Coastal Works Review

Crymble Landholdings Ltd - Seven Mile Beach – Proposed Excavation of Seabed – Block: 11B Parcel: 17

PREPARED FOR: MINISTRY OF FINANCIAL SERVICES, COMMERCE AND ENVIRONMENT

March 24, 2016

FIGURE 1: PROPOSED TRIAL EXCAVATION FOOTPRINT (SOURCE: APEC – DWG NO CWL-10, 2016)

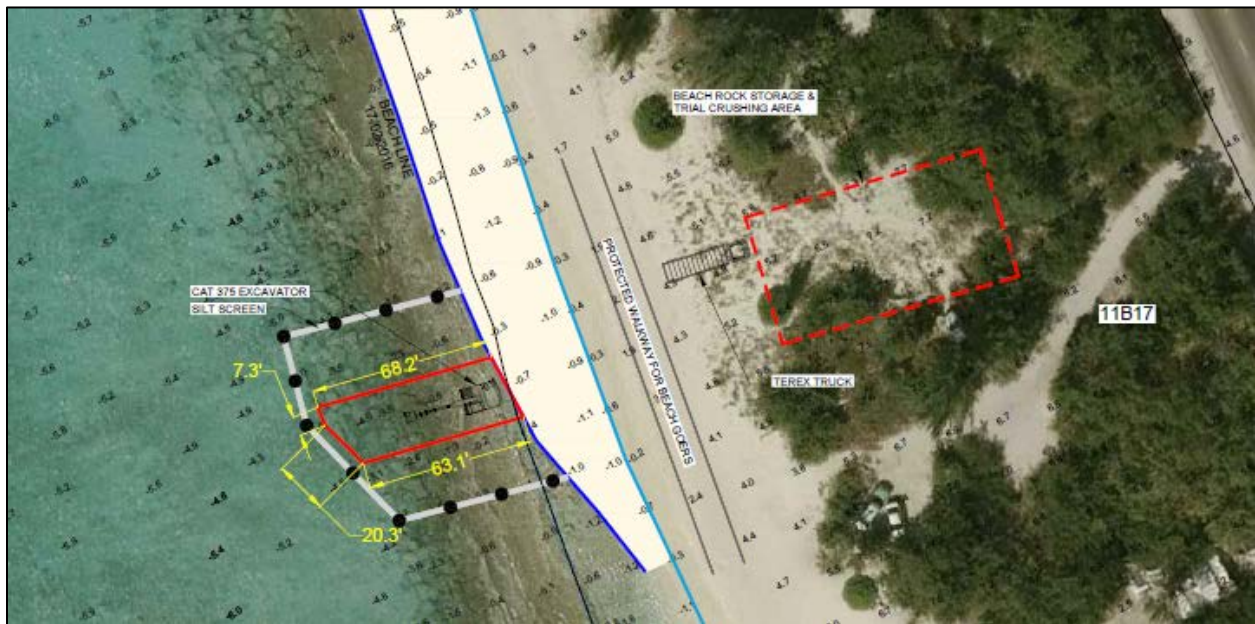
The application forms indicate that the works will result in the removal of approximately 186 cubic yards of beachrock (based on the assumption that the beachrock is approximately 3ft thick). Based on the land-based investigations there is a likelihood that the beachrock may be sitting on a layer of peat, albeit the quantity of peat is unknown at this stage.

The application also indicates that material will be used to infill the excavated seabed (approximately 125 cubic yards), which will either be comprised of “compatible beach sand from site or crushed and screened beachrock”.

1. *“To determine if a tracked excavator can lift and transport ashore the slabs of beachrock and establish the beachrock thickness”*. Beachrock is a soft substrate in geological terms. The DoE has witnessed numerous excavation projects involving harder substrate that an excavator has managed to remove with ease.

2. *“To determine if the beachrock is underlain by sand or layers of beachrock”*. The trial pit is intended to inform a significantly larger excavation project; the proposed trial will confirm the characteristics of the seabed and beachrock in this specific location but is unlikely to be representative of the 1,700 ft length of beach rock that will be the subject of a further application. Beachrock does not form in a uniform fashion and the characteristics of the trial pit will differ from the beachrock further along the coastline. The applicant could take cored samples which would be significantly less intrusive.

3. *“To determine how much sand will be required to cover newly exposed beachrock”*. As with the comment above, the characteristics of the seabed in this location may not be representative of the full extent of beachrock removal area.

4. *“To determine if the removed beachrock can be mechanically broken up to gain useful replacement sand”*. Again, it is unclear why such a substantial area of excavation is required in order to undertake this analysis. The applicant’s submission refers to the advice of Dr Seymour in respect of this proposal. In terms of crushing the rock, he advises that this should be done well away from the beach as it is unlikely to produce well grounded grains of the proper grain size.

5. *“To collect samples for a geological review and analysis”*. From correspondence with Dr Brian Jones, it is understood that 5 hand sized samples collected from the surface of the beachrock are required for the geological review and analysis.

On the basis of the above, the DoE does not believe that the rationale for the ‘trial’ excavation is adequately justified.
